HISTORIC AND DESIGN REVIEW COMMISSION

HDRC CASE NO: 2019-259
ADDRESS: 119 BUFORD
LEGAL DESCRIPTION: NCB 1369 BLK 6 LOT S 81.3 FT OF 4
ZONING: R-4, H
CITY COUNCIL DIST.: 2
DISTRICT: Dignowity Hill Historic District
APPLICANT: Mark Granato/Granato Custom Homes
OWNER: Mark Granato/DAL HOLDINGS LLC
TYPE OF WORK: Construction of a 1 story, single family residential structure
APPLICATION RECEIVED: April 30, 2019
60-DAY REVIEW: June 29, 2019
CASE MANAGER: Edward Hall
REQUEST:

The applicant is requesting a Certificate of Appropriateness for approval to construct a one story, single family residential structure on the vacant lot at 119 Buford, located within the Dignowity Hill Historic District.

Right Side Elevation

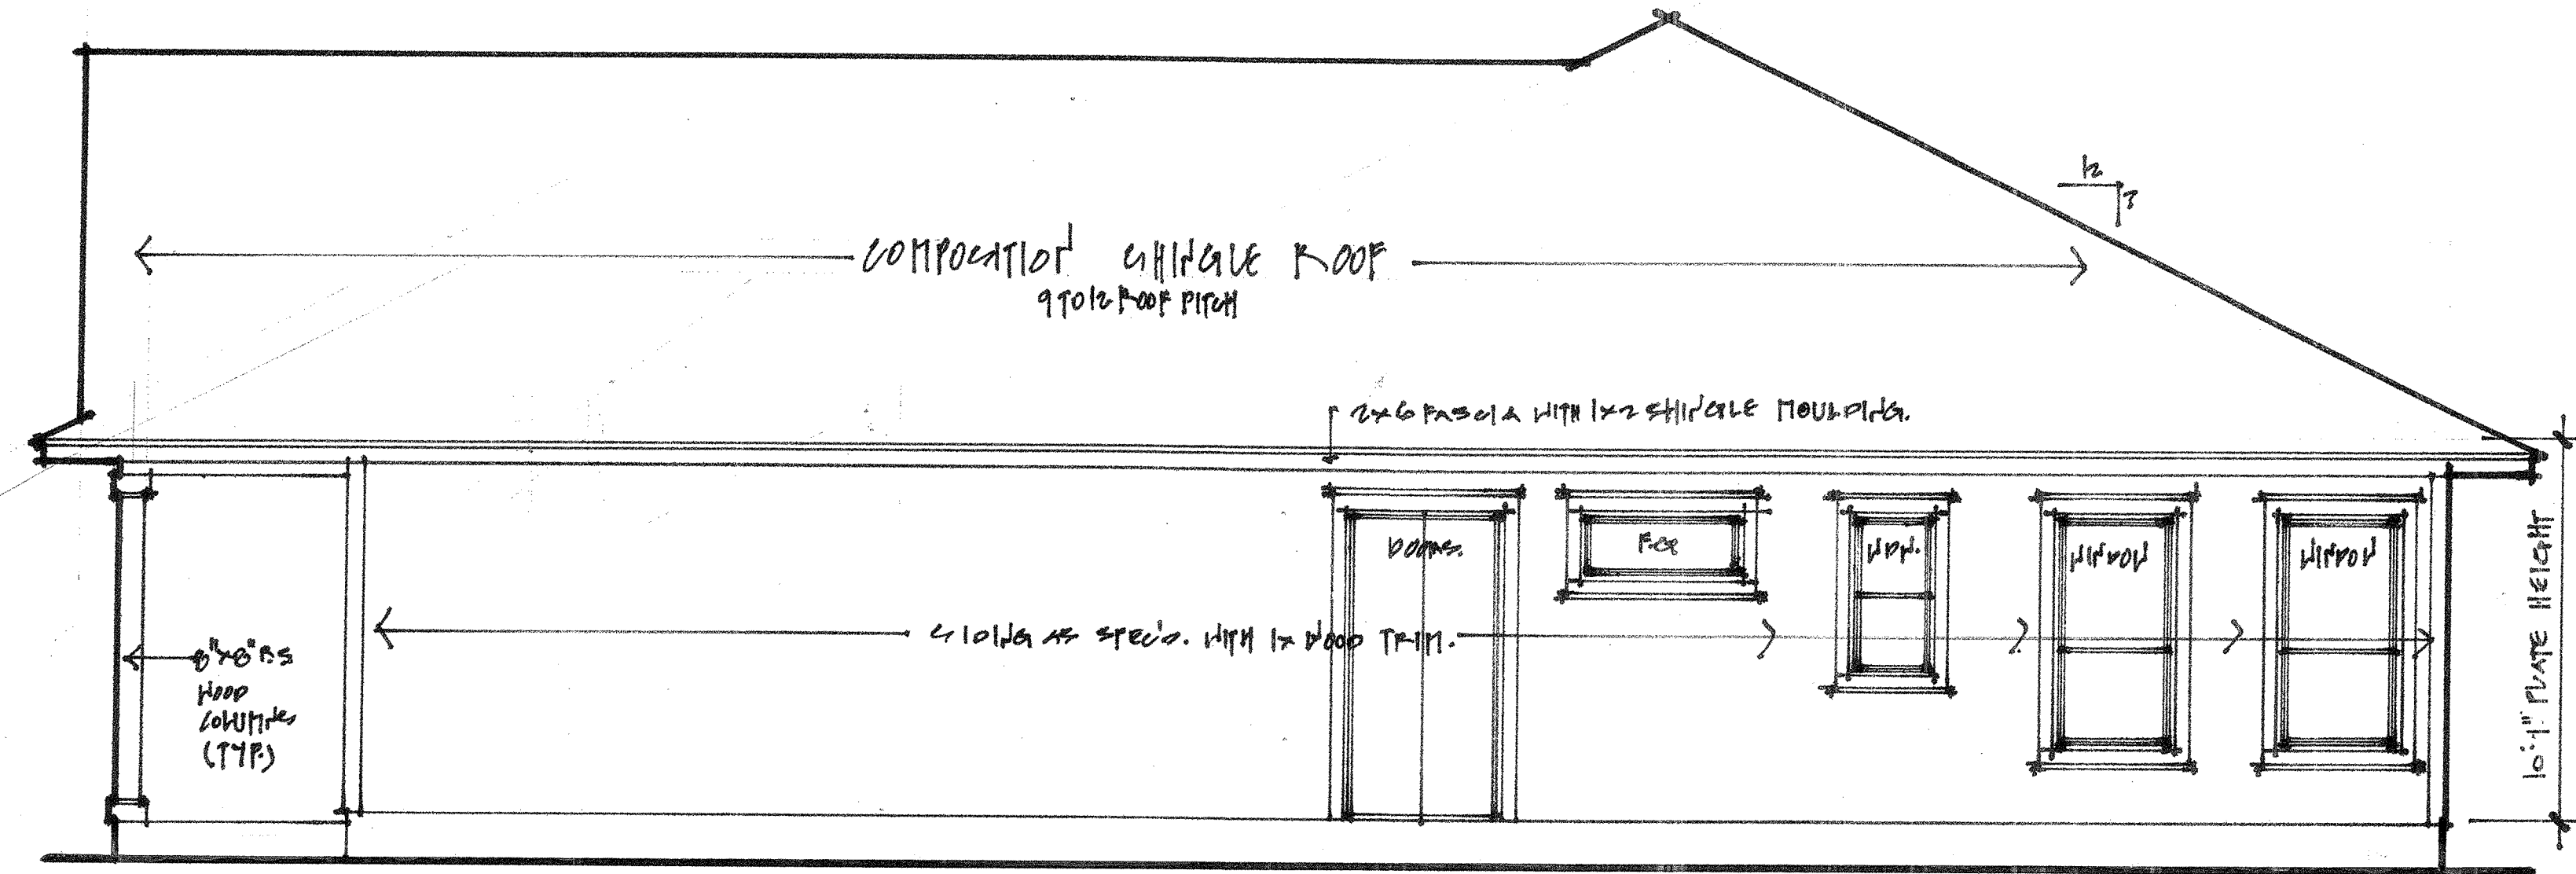
- h. **ARCHITECTURAL DETAILS** – The applicant has proposed an overall form and massing that are comparable to that found on Buford Alley and predominantly throughout the Dignowity Hill Historic District. Staff finds that additional fenestration along the east facade, particularly in the living room and on the west façade in the dining area should be added to separate wall planes that are currently blank.

- i. That the applicant confirm that the proposed setback is greater than those of the neighboring historic structures.
- ii. That the applicant incorporate additional fenestration on the east façade.
